DART SERVICE INSTRUCTION

TO AMEND INSTALLATION INSTRUCTIONS IIN-D407-781-2 REV. A OR LATER APPROVED REVISION
AND INSTRUCTIONS FOR CONTINUED AIRWORTHINESS ICA-D407-781 REV. 3 OR LATER REVISION

A	NEW ISSUE		13.04.08
REV.	DESCRIPTION	BY	DATE
DESIGN			
DRAWN			
CHECKED			
MFG. APPR.	N/A		
APPROVED			
DE APPR.			
DATE	13.04.08		
DART AEROSPACE LTD HAWKESBURY, ONTARIO, CANADA		REV. A SHEET 1 OF 2	
DRAWING NO. DSI 9649		SCALE NTS	
TITLE ALTERNATE INSTALL			
COPYRIGHT © 2013 BY DART AEROSPACE LTD. THIS DOCUMENT IS PRIVATE AND CONFIDENTIAL AND IS SUPPLIED ON THE EXPRESS CONDITION THAT IT IS NOT TO BE USED FOR ANY PURPOSE OR COPIED OR COMMUNICATED TO ANY OTHER PERSON WITHOUT WRITTEN PERMISSION FROM DART AEROSPACE LTD.

Sequence ID/ Work Center ID	Operation Description	Set Up/ Run Hours	Tool ID	Tool #	Plan Code	Accept Qty	Reject Qty	Reject Number	Insp. Stamp
Draw Nbr	Revision Nbr								
DSI9649	REV A								
100	Document Control	0.00							
100									
DC	Memo	0.00							
Doc.Control -USB or Paperwork	Photocopy bluefile &type labels per PPP D206-781-031 CHG 001								
110	Pick Kit	0.00							
110									
Packaging	Memo	0.00							
Packaging									
120	QC4- 100% Inspect kits for comple

**FIGURE 1 - D3879-1 BAGGAGE COMPARTMENT WALL
PROTECTOR - ALTERNATE INSTALLATION**

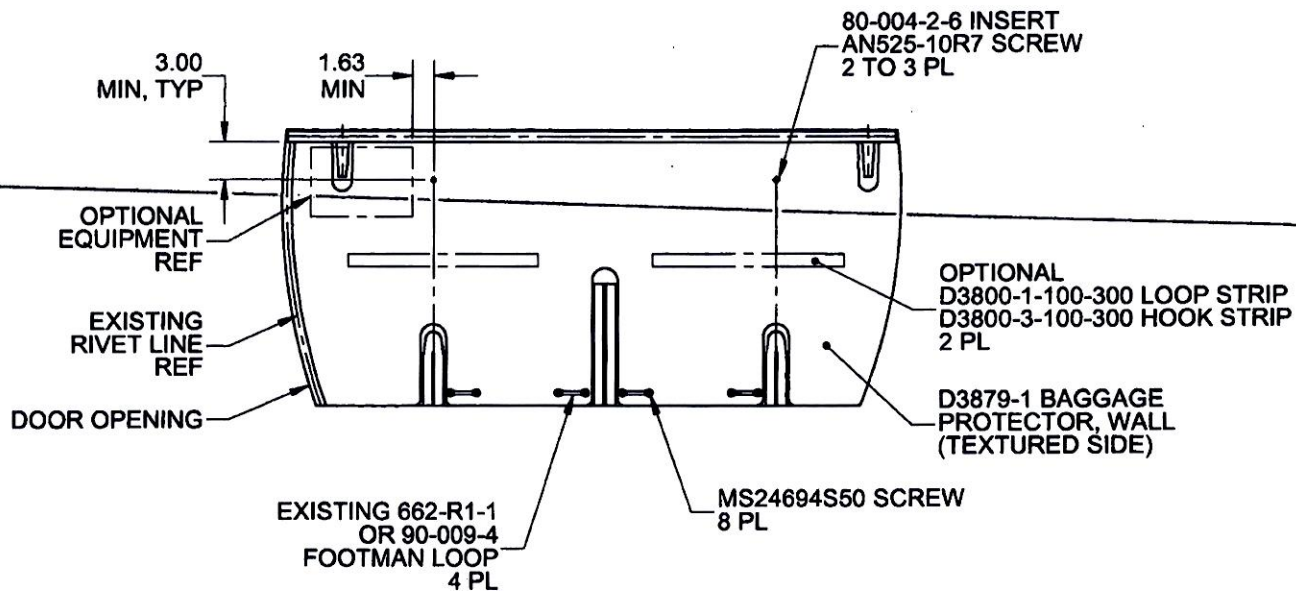
In some aircraft, the top portion of the D206-781-041 Baggage Compartment Wall Protector Kit cannot be installed as indicated in IIN-D407-781-2. The purpose of this DSI is to provide an alternate mounting method to fasten the top portion of the D206-781-041 Baggage Compartment Wall Protector Kit.

It is acceptable to replace qty(2) D3930-1 Clips with qty(2) 80-004-2-6 Inserts. Locate and mark location of the two attachment holes on the baggage compartment wall as shown in Figure 1 of this service instruction. Install 80-004-2-6 Inserts at the marked locations in accordance with Section 3-2-12 of BHT-206-SRM-1. It is acceptable to trim the wall protectors to accommodate optional equipment or transfer attachment holes to the wall protector and install the optional equipment on top of the wall protector with longer fasteners.

Amend the D206-781-041 Baggage Compartment Wall Protector Kit parts list as follows:

Qty -061	Qty -031	Qty -041	Part Number	Description
X			D206-781-061	BAGGAGE COMPARTMENT PROTECTOR KIT (FLOOR AND WALL)
1	X		D206-781-031	BAGGAGE COMPARTMENT FLOOR PROTECTOR KIT
1		X	D206-781-041	BAGGAGE COMPARTMENT WALL PROTECTOR KIT
		2	AN525-10R7	SCREW
		2	80-004-2-6	INSERT
